Subject: CESA's informal comments on the revised LA100 assumptions

Re: CESA's informal comments on the LA100 Revised Assumptions Document and the revised scenarios proposal

Figure 1. Transit Bus Driving Profile (2025, summer, one week)⁸

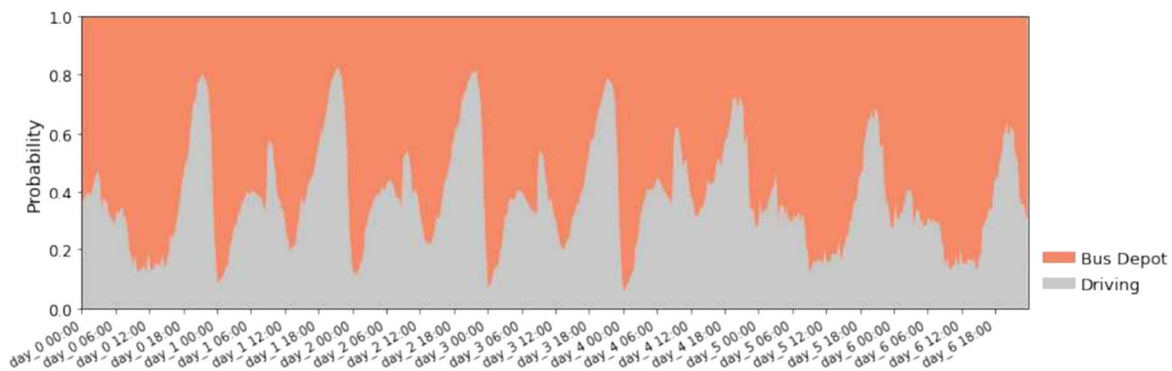
However, CESA recommends that the NREL team reconsider the degree to which electric bus charging infrastructure can be considered for load shifting capability based on the EVI-Pro

min-delay and max-delay profiles.⁵ Depending on the specific use case, some electric buses represent long dwell-time charging applications that present opportunities for load shifting. For example, school buses are typically charging during the mid-day and during after-school hours, during which bus charging could be optimized for grid benefit. CALSTART and the Union of Concerned Scientists (UCS) have noted that medium- and heavy-duty (MD/HD) EVs are typically equipped with large batteries to accommodate for the mileage and cargo load typically sought for these vehicles.⁶ Moreover, MD/HD EVs are usually in use only for 7-12 hours per day and are the primary part of operating a business or public service, such as transit.⁷ This data is further supported by an Energy + Environmental Economics (E3) analysis prepared for the California Public Utilities Commission (CPUC). Figure 1 shows a probabilistic transit bus driving profile which shows long stationary periods, even for public transit MD/HD EVs.

Figure 2. King County Metro’s Charging Demand Over One Day ¹¹

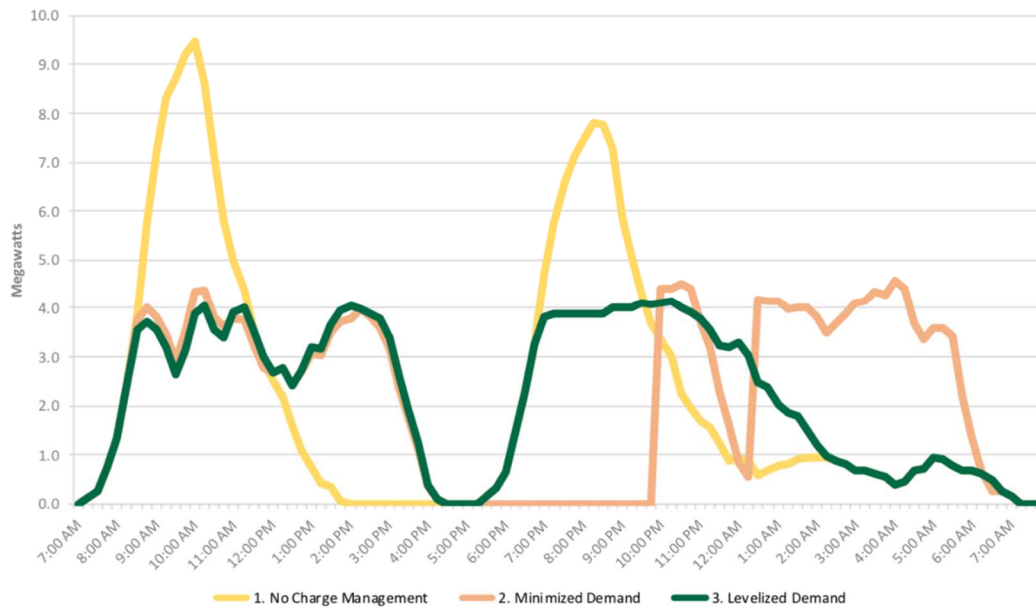
Table 1 and Figure 2 show the potential for optimizing the charging profiles of transit buses. King County’s study focuses on minimizing peak demand charges; however, charging could be optimized to shift renewable generation or even provide grid services such as frequency regulation. Experiences in California corroborate this possibility. In 2019, Nuvve, a leading aggregator, partnered with the Torrance Unified School District, Transpower, and the San Diego Unified School District to assess the potential of vehicle-to-grid (V2G) in providing grid services. This project demonstrated revenue opportunities for the provision of frequency response and, as with the previous cases, the ability to operate and charge school buses to minimize peak demand

charges.¹² In order to further the understanding of these potential applications, CESA urges NREL to share the EV charging profiles that result from this initiative with stakeholders. CESA considers this would be beneficial to developers, planners, and other governments seeking to work on other large-scale transportation electrification efforts.
